UNITED STATES PATENT AND TRADEMARK OFFICE

APPLICATION NO.	FILING DATE	FIRST NAMED INVENTOR	ATTORNEY DOCKET NO.	CONFIRMATION NO.
10/603,471	06/25/2003	Larry Gause	MSDI-259/PC757.00	3218
53196 7590 03/16/2010				
MEDTRONIC				
Attn: Noreen Johnson - IP Legal Department				
2600 Sofamor Danck Drive				
MEMPHIS, TN 38132				
EXAMINER				
RAMANA, ANURADHA				
ART UNIT		PAPER NUMBER		
3775				
MAIL DATE		DELIVERY MODE		
03/16/2010		PAPER

Office Action Summary

DETAILED ACTION

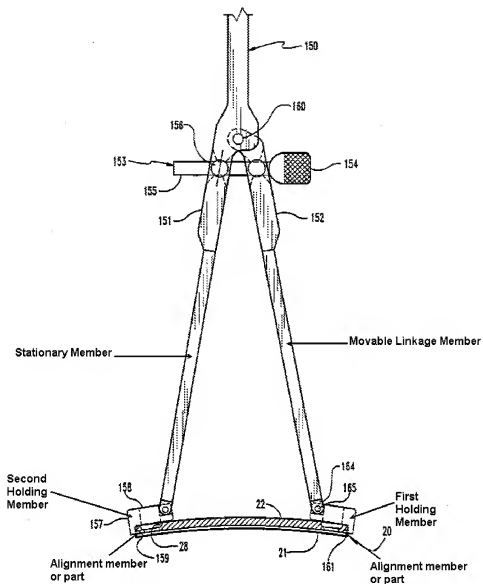
Applicant's arguments with respect to the rejections of claims 36-38 under 35 USC 102(b) over Coates et al. (US 5,423,826) have been considered but are not found

to be persuasive because Coates et al. discloses all elements of Applicant's claimed invention as illustrated in marked up Fig. 17 of Coates et al. (see following page). Guide member 180 is mounted to the stationary member when received in the second holding member. It is noted that Applicant is not claiming the guide member to be directly mounted to the stationary member. It is the Examiner's position that the recitation "mounted proximally of said holding system" only requires a portion of the guide member to be proximal to the holding system, i.e., the first and second holding members. The recitation "to guide placement of a bone-engaging fastener" is functional and only requires guide member 180 to be capable of receiving a bone fastener. In order to be given patentable weight, a functional recitation must be supported by recitation in the claim of sufficient structure to warrant the presence of the functional language. In re Fuller, 1929 C.D. 172; 388 O.G. 279.
